Subject: RE: Gas Works: Cracking Towers structure leaning

I conducted the inspection of the cracking tower structure at Gas Works. The following are my findings:

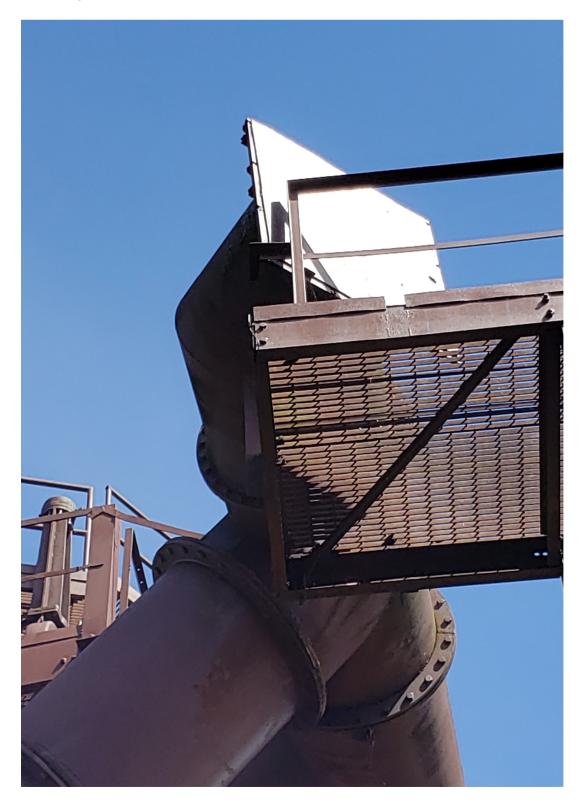
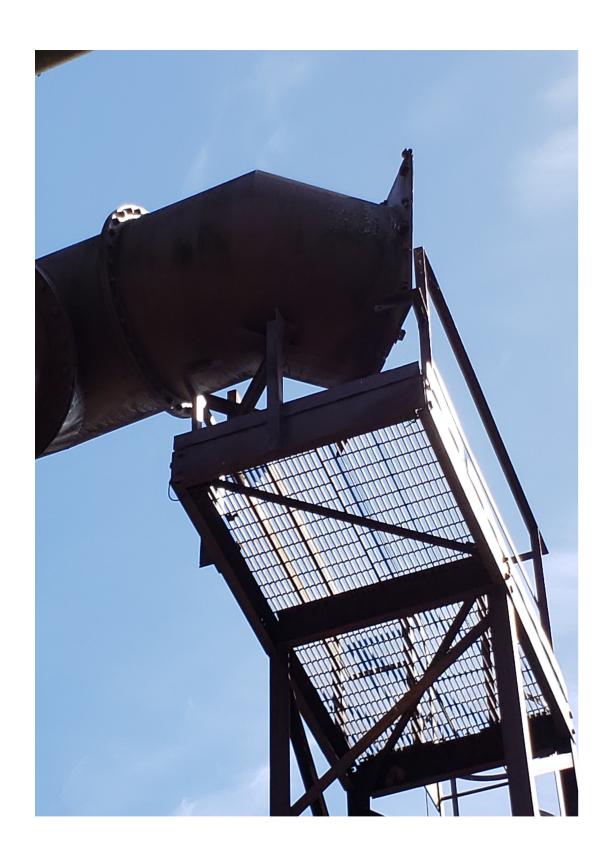
1. The southeast vertical support element of the structure is fractured at the base.

2. The southwest vertical support element is badly corroded that the steel material is peeling off, therefore reducing the effective strength of this element.

3. The northwest vertical support element is bent due to being hit by maintenance vehicle.

4. The tower structure is leaning and being prevented from falling to the ground by horizontal pipe flange that is in line with the top of the tower.

It is my recommendation that the tower structure be taken down. It is a failed structure that is unsafe to be left at its current condition/position. It is not recommended to be rebuilt or refurbished because its elements are deteriorated and badly corroded. The demolition of this tower must be done as soon as possible.
